Appendix 4 – Coverage Plots (Pre and Post structure installation)

Register Reference Number: S25421/20

RE: Application for Licence under Section 254 of the Planning & Development Act (as amended) for a 15m high telecommunications street-work structure along the R136 Cheeverstown Road, Kilmartin Green, Jobstown, Co. Dublin

Further to your letter dated 7th March 2022 requesting further information in respect of the above application please find responses answering each question in turn as follows;

Figure 1: Existing Coverage Prediction with target areas encircled

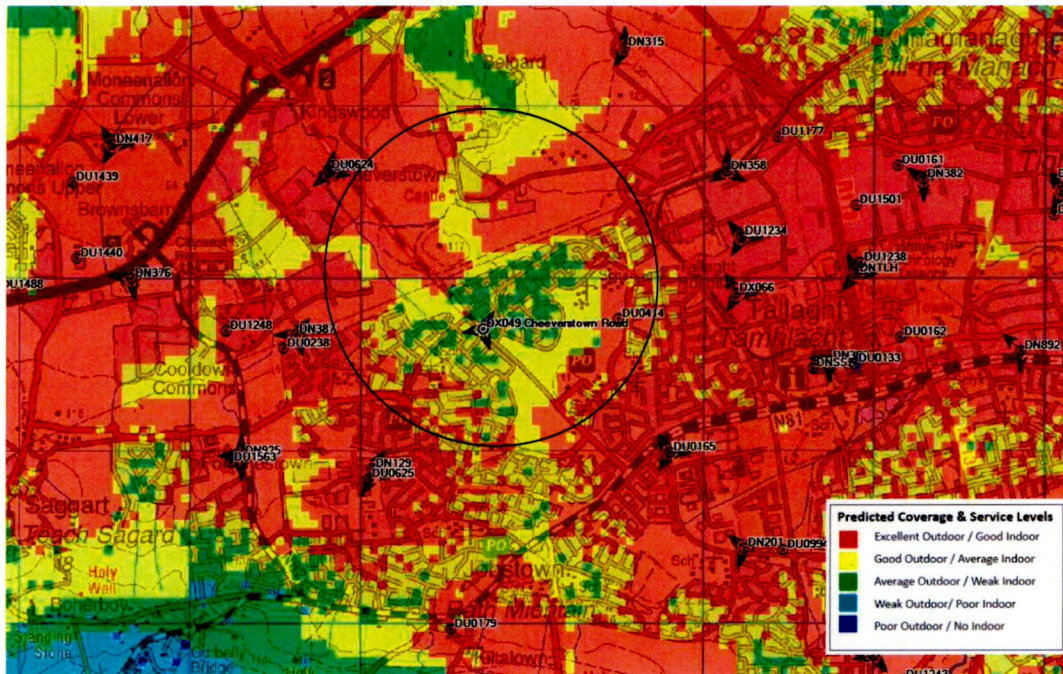
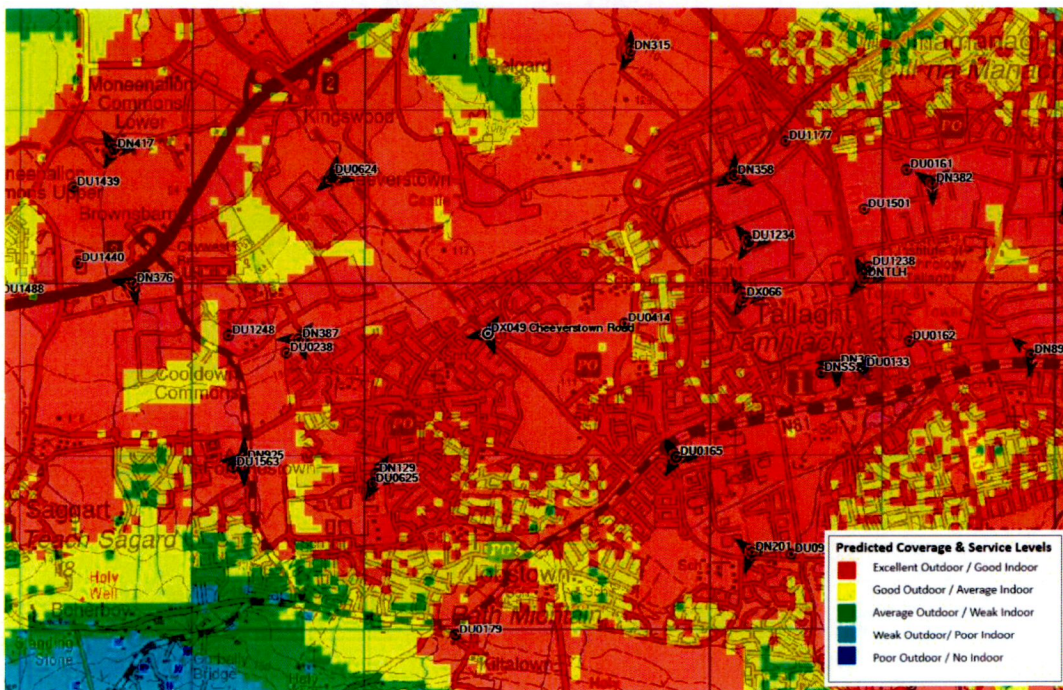
- 3. The applicant is requested to submit a report addressing Section 11.6.2 of the Development Plan. In addition to what has already been provided, this should include, but is not exhaustive:**
 - (i) A coverage map with existing and proposed coverage.**
 - (ii) A ComReg map of existing sites in the general area and a list of established sites within a 2km radius.**
 - (iii) A Visual Impact Assessment.**Please see attached Appendix 3 which contains a coverage map with existing and proposed coverage for the proposed area.

Existing and proposed coverage are set out on page 2 of the attached Technical Justification (refer Appendix 4). The maps provided highlight existing coverage, both 'good' and 'bad' by way of colours imposed over mapping.

Those areas identified in yellow and green identify areas with reasonable outdoor coverage and are in need of coverage improvement. Those areas identified in red identify areas with excellent In Car/Indoor Coverage

'Red' areas experience better indoor coverage than 'blue' areas. The mapping demonstrates on Figure 2 of page 2 demonstrate how, following the positioning of the telecommunications street furniture, a widespread localised improvement in indoor coverage as evidenced by increased area of mapping coloured 'red' whereas the current mapping (Figure 1) shows a larger palate of 'yellow and green colours' indicating the substandard level of coverage currently existing in that area.
